Agenda Item # 9

SUB-003722-2026

Pecan Ridge Estates Subdivision

- Subdivision approval to create four (4) legal lots of record from one (1) legal lot of record.

DETAIL SITE PLAN

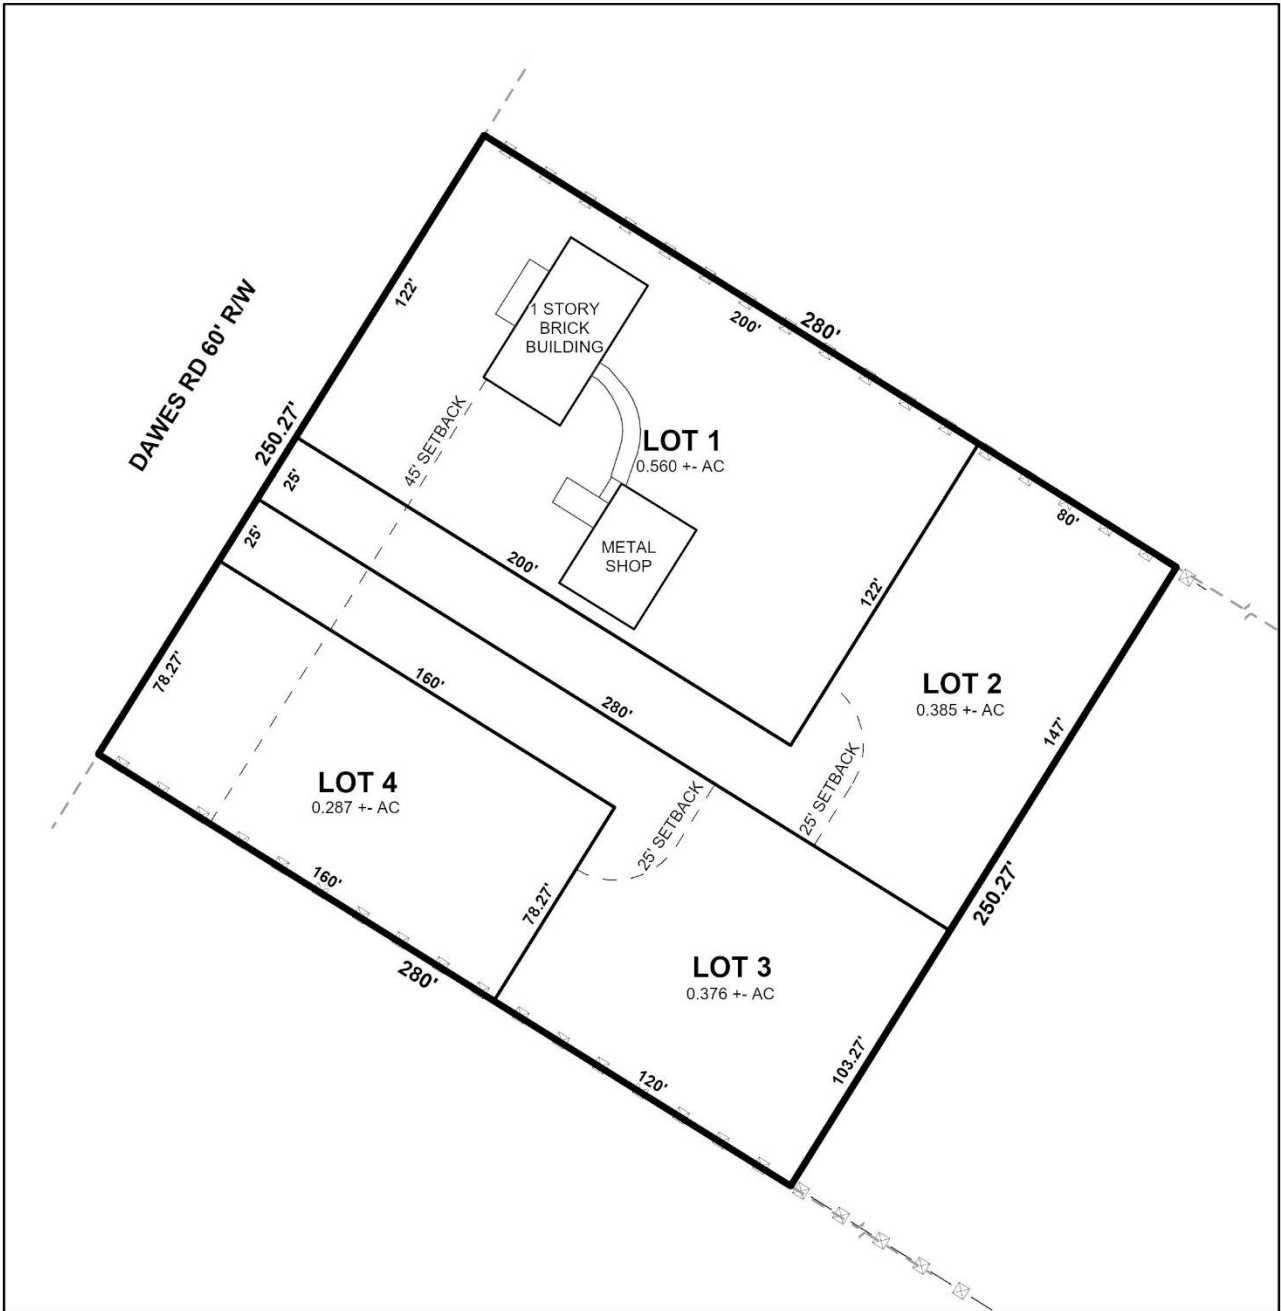
The proposed lots front Dawes Road, a Minor Arterial Street with a planned 100-foot right-of-way at this location. While the preliminary plat depicts an existing 60-foot right-of-way, the Planning Commission previously approved an increased 45-foot front yard setback in lieu of additional right-of-way dedication. The same 45-foot front yard setback is proposed with this application and may again be appropriate as an alternative to additional dedication. Should the Commission determine that additional dedication is unnecessary, a waiver of Section 6.B.9. of the Subdivision Regulations will be required.

Proposed Lots 1 and 4 exceed the minimum 60-foot lot width requirement along Dawes Road, as prescribed by Section 6.C.2.(b)(4) of the Subdivision Regulations for residential lots within the Suburban Sub-District. Proposed Lots 2 and 3, however, are designed as flag-shaped lots, each providing a 25-foot-wide pole along the street frontage. Such lot configurations are generally discouraged by Section 6.C.9. of the Subdivision Regulations except in unusual circumstances or in areas where varied and irregular lot patterns are common. Flag-shaped lots are not characteristic of the surrounding area, and no unusual site conditions appear to exist that would necessitate the proposed design. Therefore, approval of the subdivision will require a waiver of Section 6.C.9. of the Subdivision Regulations.

In addition to the 45-foot front yard setback depicted along Dawes Road, 25-foot front yard setbacks are illustrated on the portions of the proposed flag-shaped lots that widen to at least 60 feet. The 25-foot setback is consistent with Article 2, Section 64-2-5.E. of the Unified Development Code (UDC) and Section 6.C.8. of the Subdivision Regulations for lots within the R-1, Single-Family Residential Suburban District. If approved, these setbacks should be retained on the Final Plat.

1. Retention of the 45-foot front yard setback on the Final Plat in lieu of additional right-of-way dedication;
2. Retention of the lot sizes in both square feet and acres as a label on the Final Plat, or provision of a table on the Final Plat providing the same information;
3. Retention of the 25-foot front yard setback along Dawes Road where Lots 2 and 3 are at least 60 feet wide, in compliance with Section 64-2-5.E. of the Unified Development Code and Section 6.C.8. of the Subdivision Regulations;
4. Compliance with all Engineering comments noted in this staff report;
5. Compliance with all Traffic Engineering comments noted in this staff report;
6. Compliance with all Urban Forestry comments noted in this staff report; and,
7. Compliance with all Fire Department comments noted in this staff report.
